UNITED STATES PATENT AND TRADEMARK OFFICE

APPLICATION NO.	FILING DATE	FIRST NAMED INVENTOR	ATTORNEY DOCKET NO.	CONFIRMATION NO.
10/687,600	10/20/2003	Makoto Morishima	520.43227X00	2551

Office Action Summary	Application No. 10/687,600	Applicant(s) MORISHIMA ET AL.	
	Examiner Raymond Alejandro	Art Unit 1745

DETAILED ACTION

Fig. 6

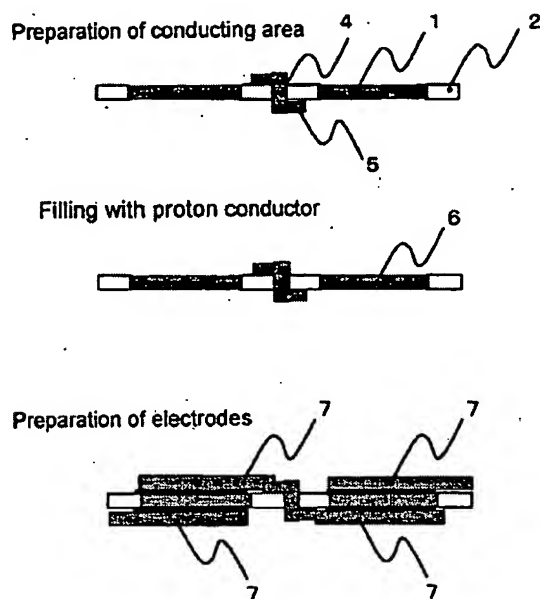
Figure 6 below of Kidai et al depicts a polymer electrolyte membrane comprising a plurality of electrodes 7 consisting of respective electrode substrates and electrocatalyst layers

(P.0058). It is disclosed that connections occur between the anodes and the cathodes located in the opposite sides of the polymer electrolyte membrane, wherein it is preferably to have a structure which interposes electron conductor the polymer electrolyte membrane (P0011). Reference numeral 5 represents the electron conductor through membrane (*the wiring member which electrically connects adjoining electrodes*) ; reference numerals 1 and 2 represent respective porous area and non-porous area of the polymer electrolyte membrane (P0025-0031).

(Emphasis supplied→) EXAMPLE 1 exemplifies the preparation of a multipore film having a porous area 1 and non-porous area 2; wherein the porous area 1 is filled with the Nafion proton conductor (EXAMPLE 1/ P0100-0103). *The electrolyte membrane having a slot may be represented by either the membrane permeating area 4 including the electron conductor through membrane 5 or the multipore film having a porous area (slots).* The anode, cathode and electrolyte are separated by a separator (P0005). *In the instant case, the separators serve as the plurality of wiring plates covering respective cathodes and anodes.* Electrodes 7 are connected through respective electron conductor through membrane 5 (See FIGURE 6).

Examiner's note: *It is noted that the plurality of both negative electrodes and positive electrodes satisfy the claimed requirement of having opposed anode and cathode electrodes in pairs with the solid polymer electrolyte interposed therebetween. It is further noted that the negative electrode performs the inherent function of oxidizing the fuel gas, and the positive electrode performs the inherent function of reducing the oxidant.*
